SL-GA8-2012-13 Issue 1

# **Service Letter**

Replacement Vacuum Switch

All GA8 aircraft fitted with vacuum switch P/N GA8-372011-011.

Figure 1 Side view of the installed switch.

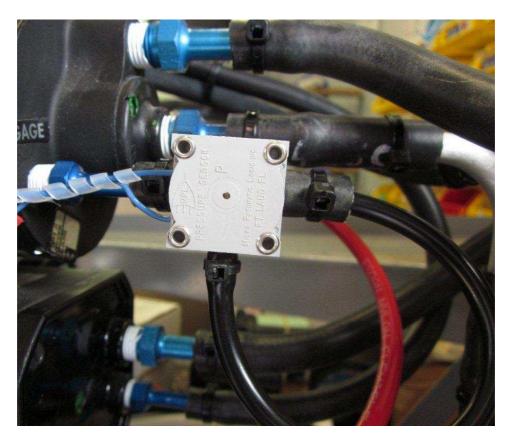
Unsatisfactory reliability of the original Vacuum system warning switch has required the introduction of a new switch P/N GA8-372012-011, which supersedes switch P/N GA8-372011-011. The GA8-372011-011 switch remains "On Condition" and need only be replaced with the new switch on failure. The GA8 IPC will be revised to reflect this change.

This vacuum switch has been set to close with an applied vacuum pressure of 2.75 inches of Hg +/- 0.25. This is 1 inch Hg lower than the original switch.

- 1. Remove Flight Instruments Sub Panel.
- 2. Remove the original switch from the flight instrument panel.
- 3. Install the switch as shown in Figures 1 and 2.
- 4. Fit a cable tie over the hose joined to the inlet of the switch. Pull tight. Cut off the cable tie end cleanly ensuring that no sharp edge is present.
- 5. Connect circuits WV1B22 and WV1C22N to the terminals of the vacuum switch assembly. The switch is not polarised.
- 6. Re-install Flight Instruments Sub Panel.

NOTE:
The cable tie used around the short hose shown shall be firm, but not excessively tight so as to cause a restriction.
